SUPPLEMENTAL INFORMATION REPORT FOR THE
SOUTH SAN FRANCISCO BAY SHORELINE PROJECT
Santa Clara County, California

February 2023

7.0 Appendix A: Public Comments and Responses

Figure 1. Project Reaches and Proposed Haul Route

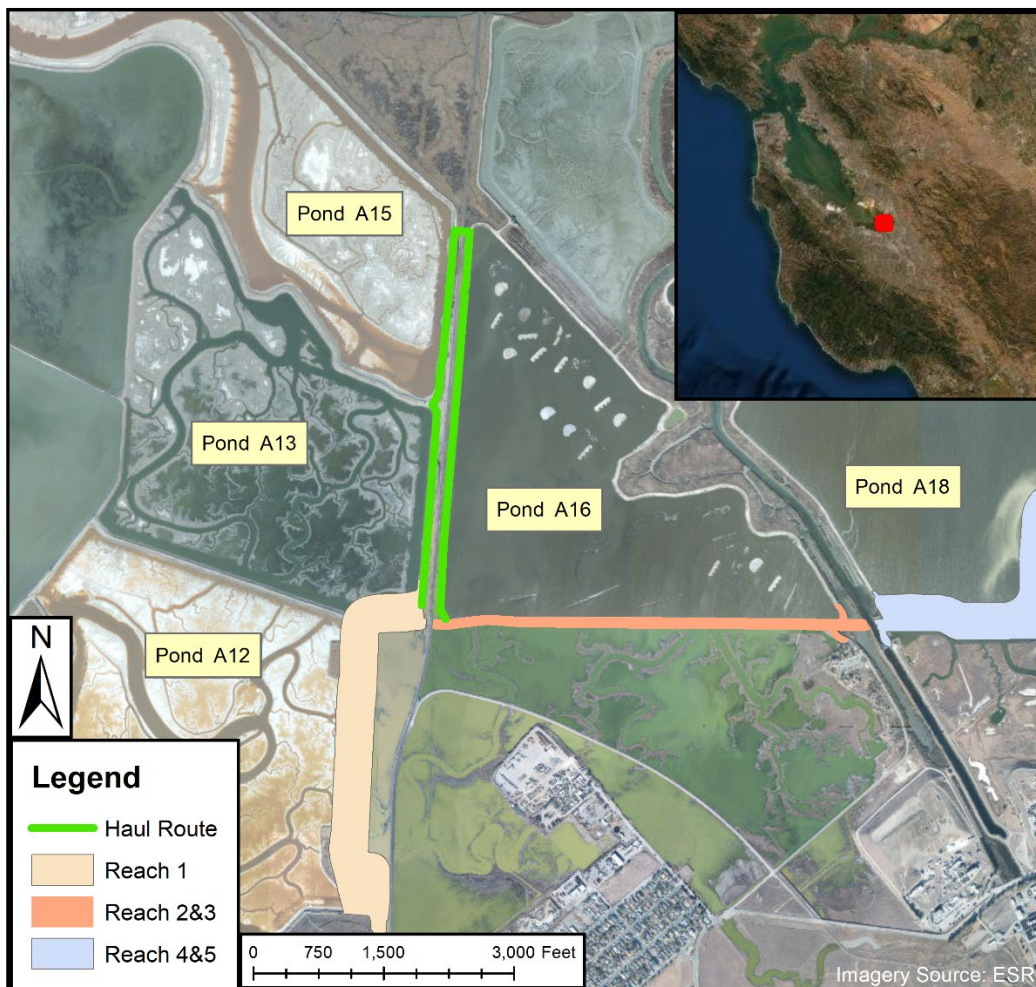
I am contacting you regarding the Supplemental Information Report (SIR) for the South San Francisco Bay Shoreline Project published in November 2022. Specifically, I would like to provide two comments regarding the proposed alternate haul route that would extend along the western edge of pond A16, cross the Union Pacific Rail Road crossing near the A16 northwest corner, extend south along the eastern edge of ponds A15 and A13, and eventually reach the construction area along the eastern edge of A12.

My first comment is in regards to the impact that this alternate haul route could have upon breeding Western snowy plovers (snowy plovers) in pond A15. During the 2022 breeding season the San Francisco Bay Bird Observatory (SFBBO) documented pond A15 as supporting the second largest amount of plover breeding activity in all of USFWS Recovery Unit 3 (the San Francisco Bay estuary), with 39 nests monitored to fate and at least 4 additional nests detected at the brood stage (Pearl et al. In Progress). Of these 39 monitored nests, 2 were located within 300ft of the levee east of A15 where the proposed alternate route would be. Snowy plovers are habituated to the noise of trains in this area, and it is not anticipated that haul trucks along this levee would cause significant disturbance to incubating snowy plovers. However, they are not habituated to pedestrians in this area, particularly since public access to this area has been limited for multiple years now. If construction crew or truck drivers were to stand on this stretch of the levee it could cause incubating snowy plovers within 300ft to flush off their nests, and if this disturbance were to occur for an extended period of time, could cause nest abandonment. To eliminate this issue, no individuals should be standing on this stretch of levee during the breeding season (March 1-September 15) for more than ten minutes. If there is a

need for an individual to stand on this stretch of levee for more than ten minutes, they should be within or behind a vehicle, which acts as a blind. Additionally, snowy plover broods have been observed foraging both along the eastern edge of pond A15 and along the shoreline of the levee east of pond A15 where the proposed haul route is located. As such, hauling activities could cause take of snowy plover broods. To eliminate this issue, the levee and shoreline along the east side of A15 must be visually cleared each day by a qualified biologist using a spotting scope before any hauling activities begin.

- 1) Construction Avoidance and Minimization Measure (AMM) TBR-2B for western snowy plovers requires individuals to stay outside a 300¹ foot buffer for nests and broods when stopped on a haul route, but does not specify an amount of time individuals can be outside their vehicle before taking cover behind a blind. There is no need for a time limit on individuals outside their vehicles because AMM TBR-2B requires individuals to stay outside of the 300 foot buffer distance when stopped. The only reason individuals would need to encroach on the 300 foot buffer is for inspection, maintenance, research, and monitoring activities which AMM TBR-2B includes may only be performed within the buffer distance while under the supervision of a qualified biologist. Therefore due to the buffer distance and biological monitoring, project activities are not expected to cause a disturbance such as flushing or nest abandonment. Please see Minimization Measure TBR-2b on page 4-379 of the Integrated Feasibility Report (IFR) for construction avoidance measures for western snowy plovers.

1: Please see the SIR published in November, 2020 which modified the 600-foot buffer distance for plover nests and broods originally included in the IFR to 300- feet.

- 2) The IFR requires onsite biological monitoring for construction activities that occur adjacent to western snowy plover habitat. The qualified biologist will monitor across the entire project site in any place they believe interactions with endangered species will likely occur, including haul routes. For this reason, there is no specification in the IFR that one construction area will take priority over another area.
